SECTION 4.55 APPLICATION
33 UPPER CLIFFORD AVENUE
LOT C DP 102834 FAIRLIGHT
DA166/2015

S4.55 APPLICATION DRAWING LIST

DEVELOPMENT CONSENT DA-166/2015
NORTHERN BEACHES COUNCIL
DEVELOPMENT MODIFICATION MOD2018/0715
BASIX CERTIFICATE No A336197_03

S4.55 APPLICATION
ADDITIONS & ALTERATIONS
33 UPPER CLIFFORD AVENUE
FAIRLIGHT

GROUND LEVEL PLAN

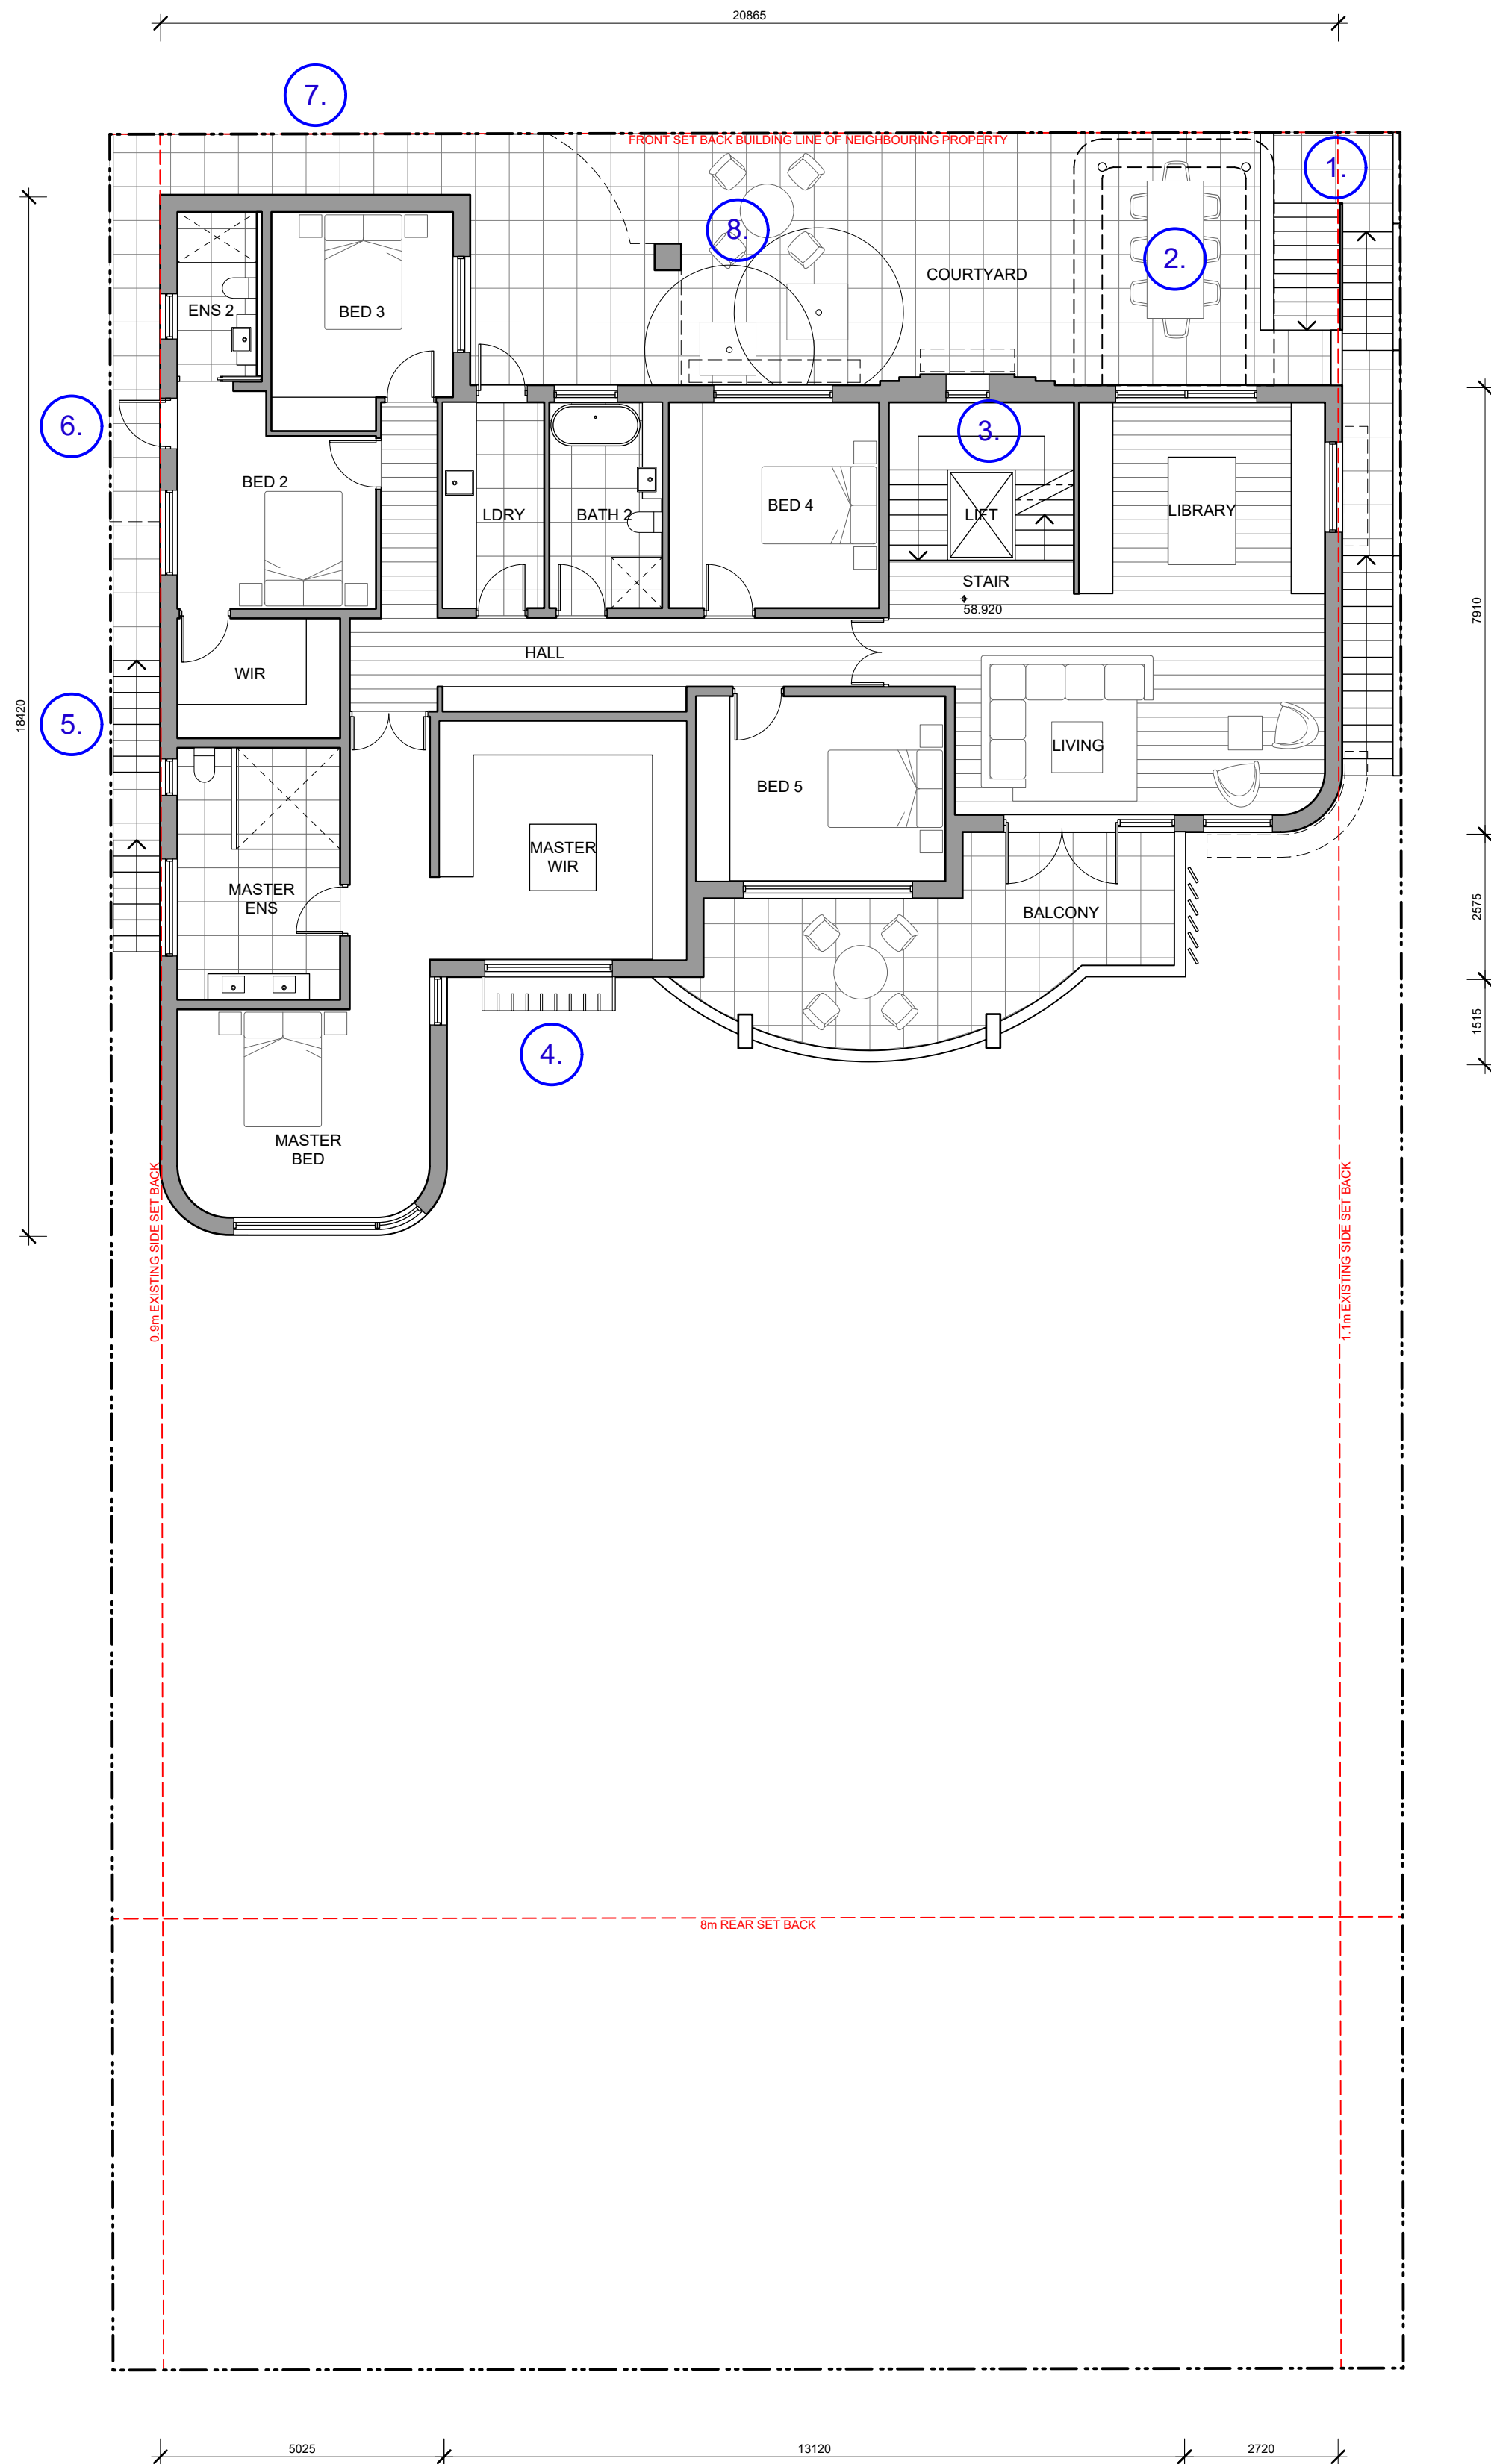
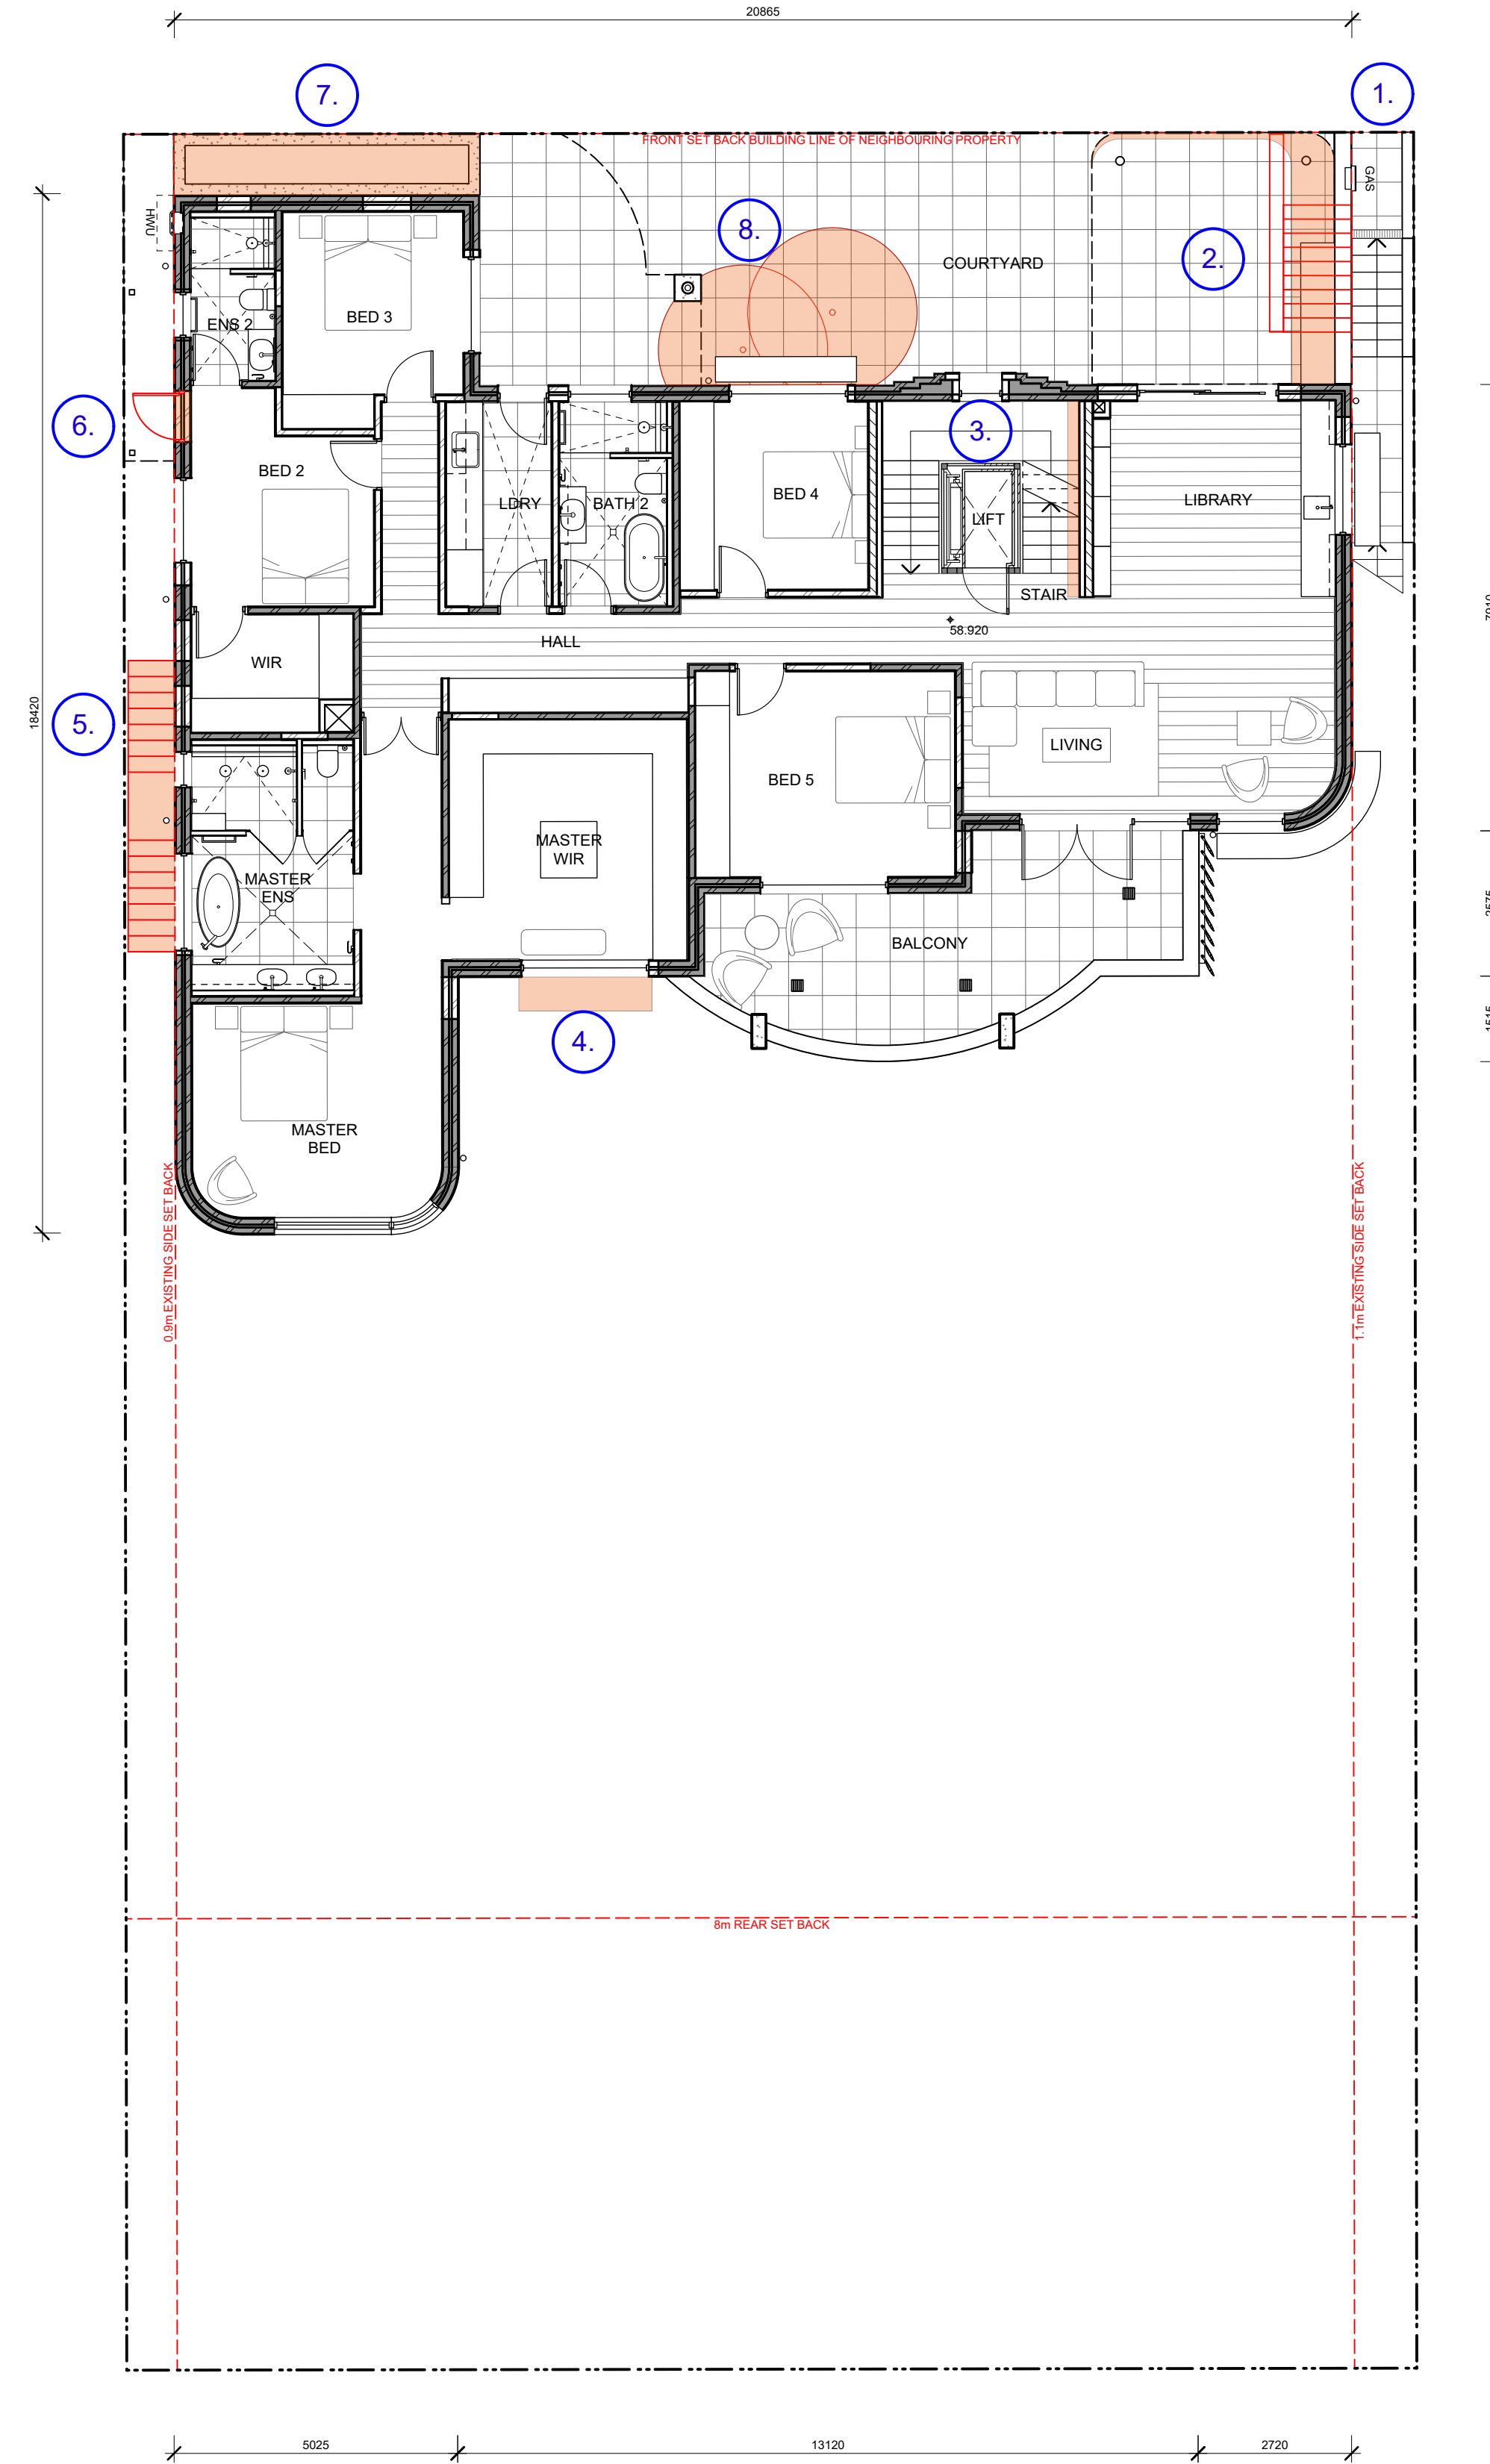
1. REMOVE COURTYARD STAIR ACCESS
2. MINOR INCREASE TO COURTYARD CANOPY
3. REVISED INTERNAL STAIRCASE CONFIGURATION
4. REMOVE MASTER WIR WINDOW AWNING
5. REMOVE WESTERN STAIR ACCESS
6. REMOVE EXTERNAL ACCESS FROM BED 2
7. RELOCATION OF RAIN WATER TANK
8. REMOVE EXISTING PALM TREES
